STATUS CODE DESCRIPTION
ISSUED FOR FURTHER INFORMATION

PROJECT
ADAMSTOWN STATION BLOCKS ACD

DRAWING
BLOCK D ELEVATIONS

STATUS CODE:	DRAWING NUMBER	REVISION
A1	ADC3-HJL-ACD-ZZ-DR-A-P2014	P02

4 Block D - North Elevation
1 : 200

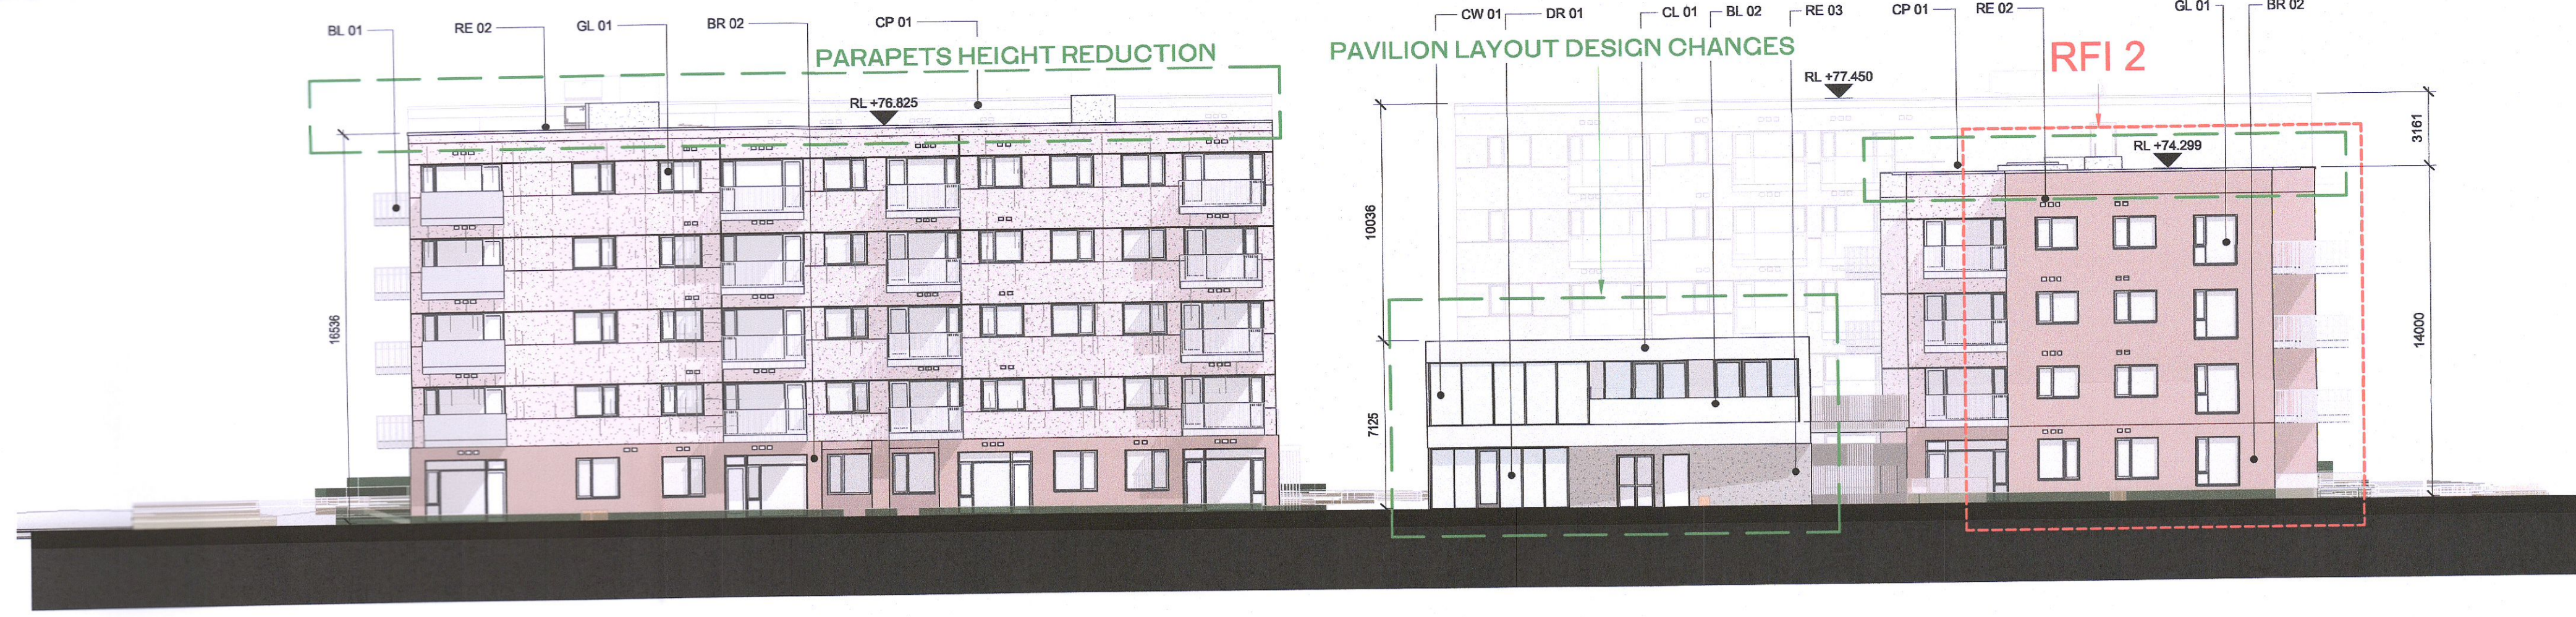
- RFI 1 (a)**
Block D North - changes to Core entrance hall facing Great Western Way updated to accommodate new apartment type T.102_D
- RFI 1 (b)**
Block D South - Changes to apartment type T.201_D and T.202_D to overcome privacy/overlooking issues
- RFI 2**
Block D South - Changes to facade material to brick on the upper floor levels
